Access Compliance Report

Public Rights-of-Way (Curb Ramps)

Intersection ID: 54193	Main Street: SYCAMORE CENTRE DR	Cross Street: TYVOLA CENTRE DR	Location: NE
ADA ID: F22657786F66	Ramp Type: BlendTrans1	Initial Pass/Fail: Pass	Overall Compliance: No
Codes/Mitigation Info/Possible Solution			Severity Score: 0
			Field Measurements/Component Compliance

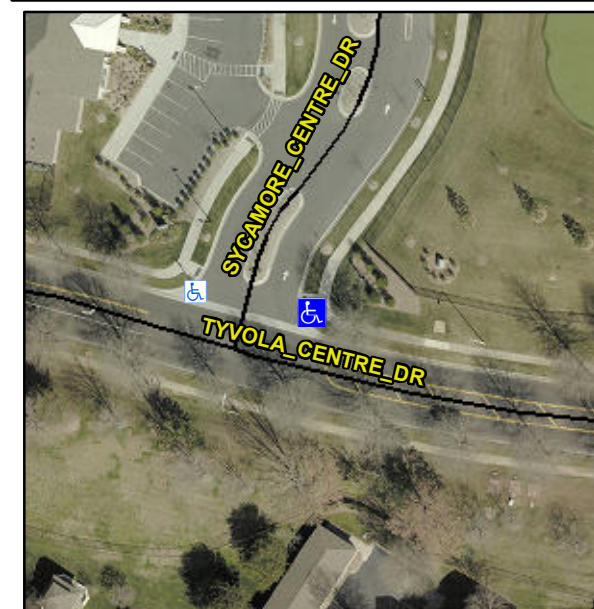
R305.2

**Remove & Replace Detectable
Warning System.**
